## Executive Director's Recommendation

Commission Meeting: September 3, 2020

<b>PROJECT</b> <b>Utility Vault and Parking Garage MLP-15</b> National Institutes of Health, Bethesda Campus 9000 Rockville Pike Bethesda, Maryland	<b>NCPC FILE NUMBER</b> 8207  <b>NCPC MAP FILE NUMBER</b> 3101.20(05.00)45182  <b>APPLICANT'S REQUEST</b> Approval of preliminary and final site and building plans  <b>PROPOSED ACTION</b> Approve preliminary site and building plans with comments  <b>ACTION ITEM TYPE</b> Staff Presentation
<b>SUBMITTED BY</b> United States Department of Health and Human Services National Institutes of Health	
<b>REVIEW AUTHORITY</b> Federal Projects in the Environs per 40 U.S.C. § 8722(b)(1)

# Tree Removal / Replacement

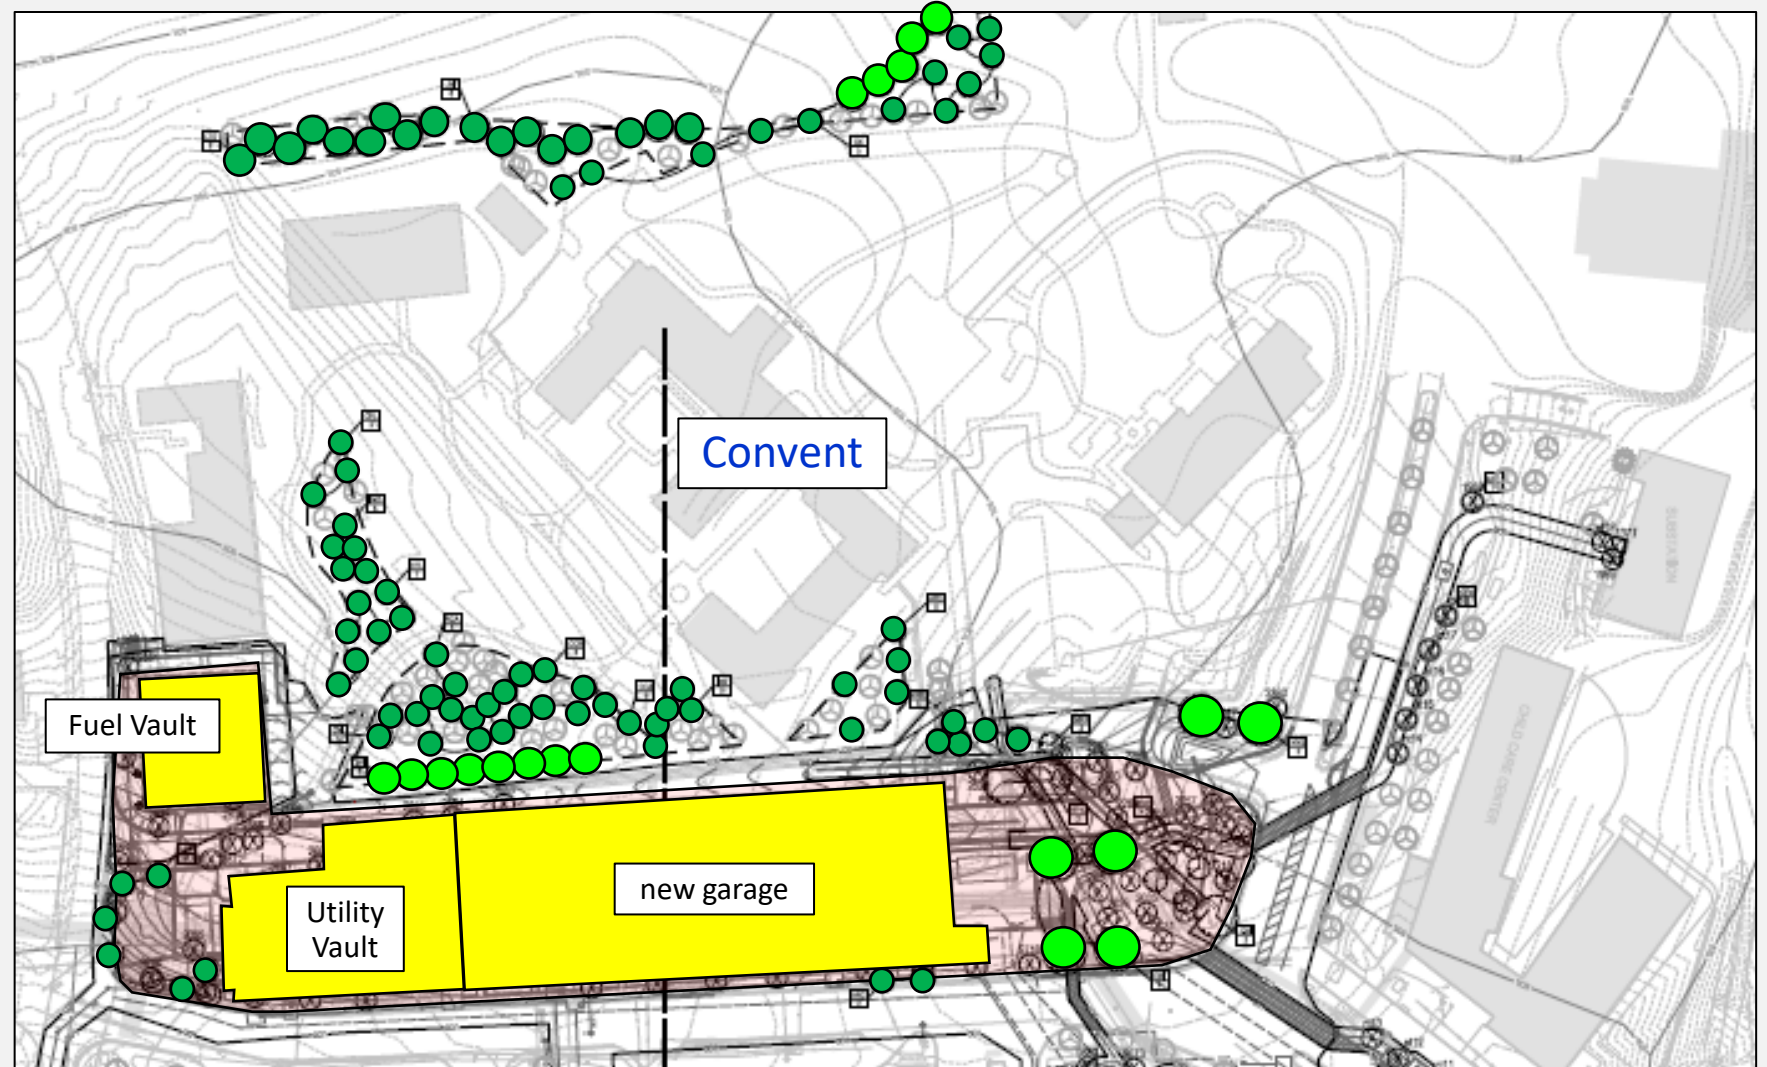
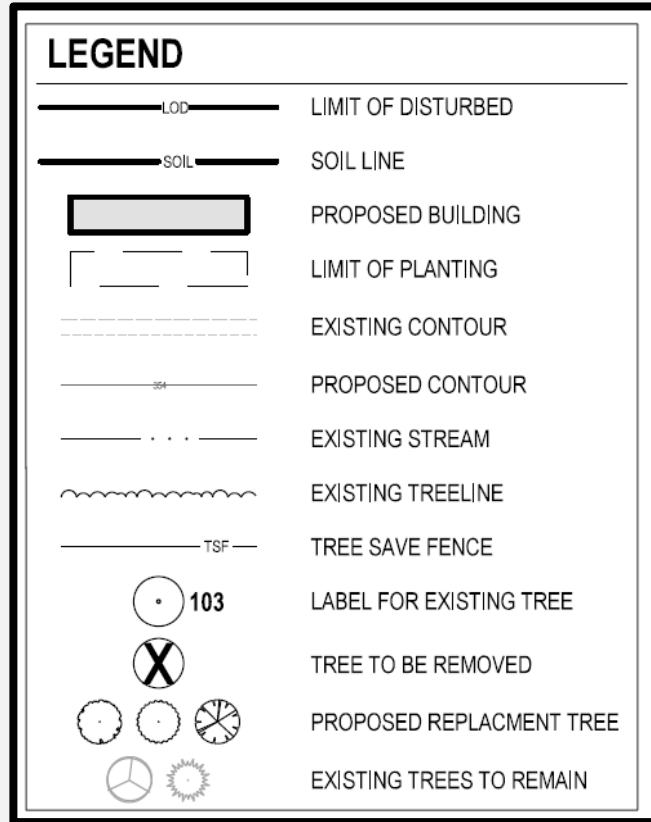
NIH has tree replacement policies which recommend one-to-one replacement for smaller trees and a higher ratio for larger trees; however, the project's proposed replacement would not fully replace the number of trees removed. NCPC is currently revising its tree policies to reflect the latest industry standards and Best Management Practices from local jurisdictions in the Region, with draft replacement policies based on tree size, species, and condition ratings. The intent of the updated Commission policies is to prevent a net tree canopy loss. Staff believe that the proposed tree mitigation could be accomplished in a more effective manner than currently reflected in preliminary landscape plans. Therefore, staff recommends that the Commission **recommend that NIH restore the area's wooded character to the extent possible by implementing a more effective and robust landscape design based on the following NCPC draft guidelines:**

- **Replace trees with a mix of native evergreen and deciduous shade trees similar to the existing mix on the Convent grounds and project site;**
- **Plant replacement trees with a minimum caliper size of 2.5 inches for shade trees, 1.5 inches for ornamental trees, and six-foot height for multi-stem and evergreen trees;**
- **Replace existing trees that measure less than 10-inches in diameter at a one-to-one (1:1) ratio; and**
- **Replace existing trees that measure 10-inches in diameter or more at a higher ratio based on the condition of each tree removed. Existing trees with a condition rating of “Fair,” “Good,” or “Excellent” should be replaced at a minimum two-to-one (2:1) ratio.**

# Fuel Tank Vault

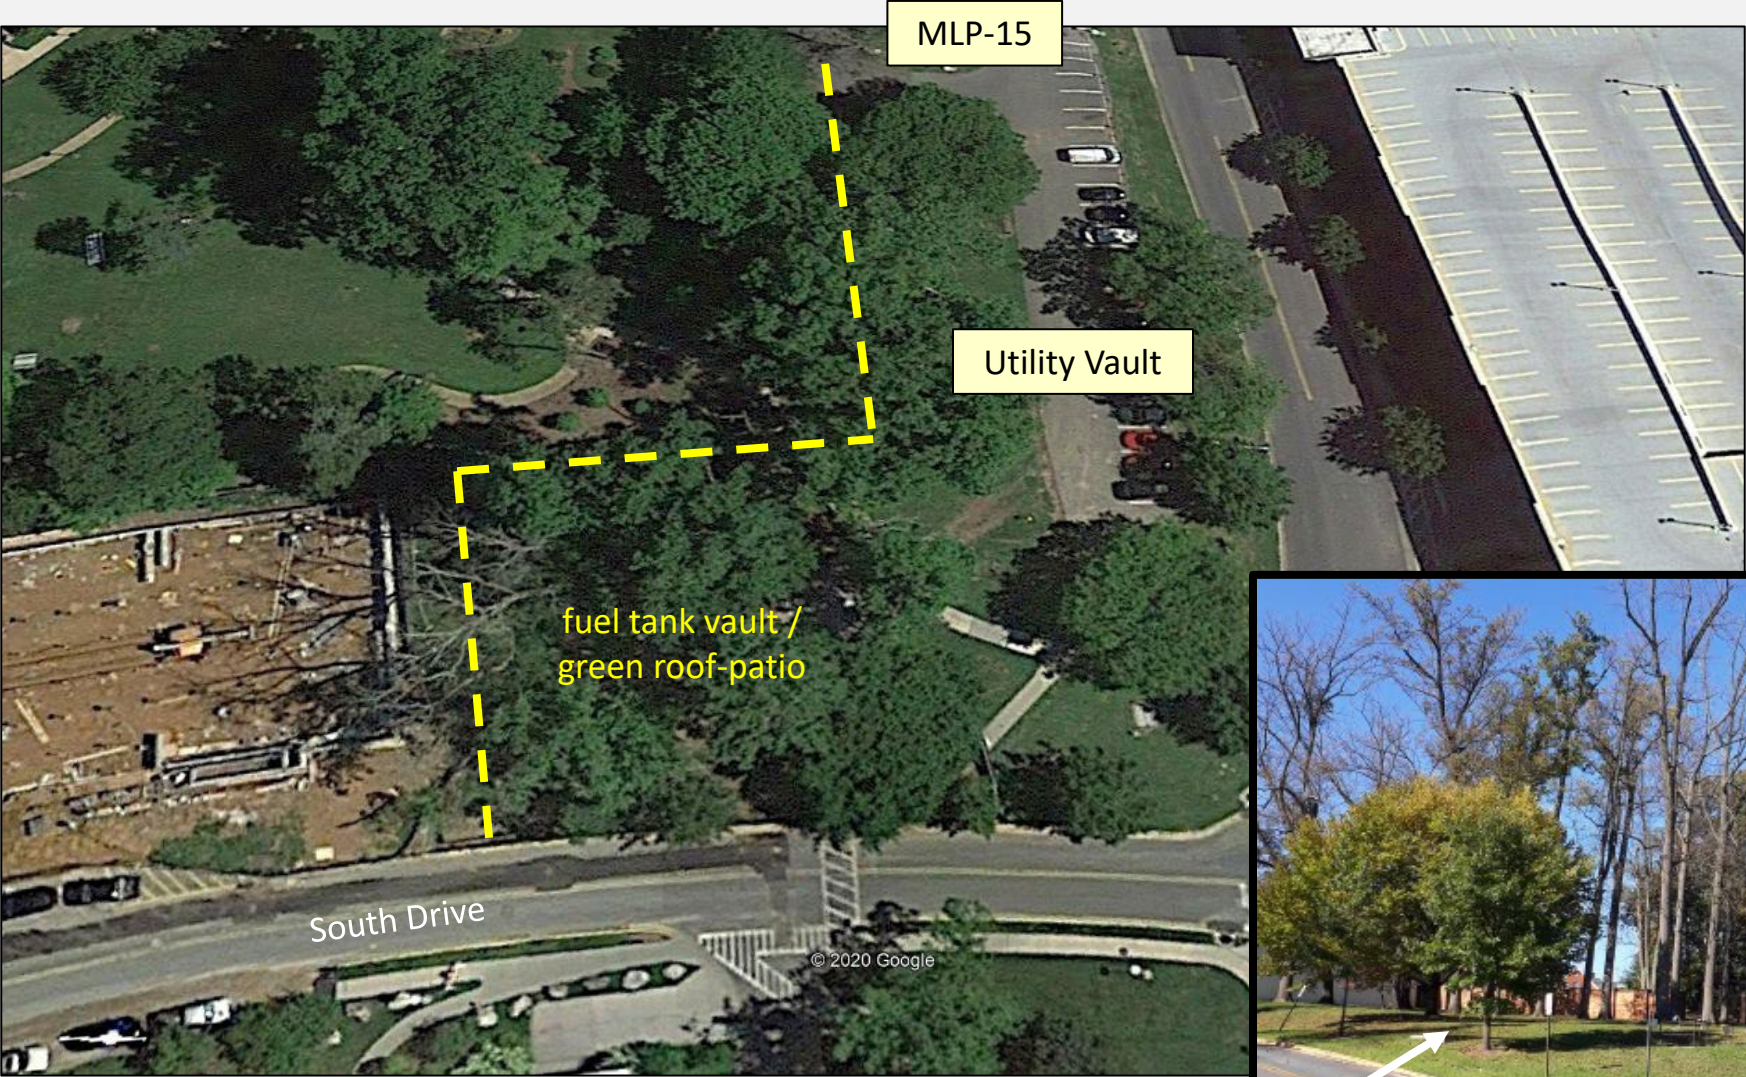
NIH proposes to construct the fuel tank vault with sedum plants (extensive green roof) and stone patterns surrounding a small plaza on the vault roof. While extensive green roofs offer many environmental benefits, the low-profile and openness of the extensive roof would contrast with the existing, mature wooded character of the site. To maintain more of the existing character, the applicant should explore methods to increase the soil depth above the vault structure to support small trees and shrubs. Additional soil depth can be achieved by mounding the soil and/or constructing low landscape walls that may be used for seating and supporting additional soil. An intensive or semi-intensive green roof treatment would create a more park-like setting for the proposed pedestrian plaza, thereby adding to the potential quality of the space. Therefore, staff recommends that the Commission **recommend a more robust intensive green roof over the new fuel tank vault with ornamental trees and shrubs to help restore the wooded character of the site and to create a more sheltered, pleasant setting for the proposed pedestrian plaza.**

**Recommends** a more robust intensive green roof over the new fuel tank vault with ornamental trees and shrubs to help restore the wooded character of the site and to create a more sheltered, pleasant setting for the proposed pedestrian plaza.
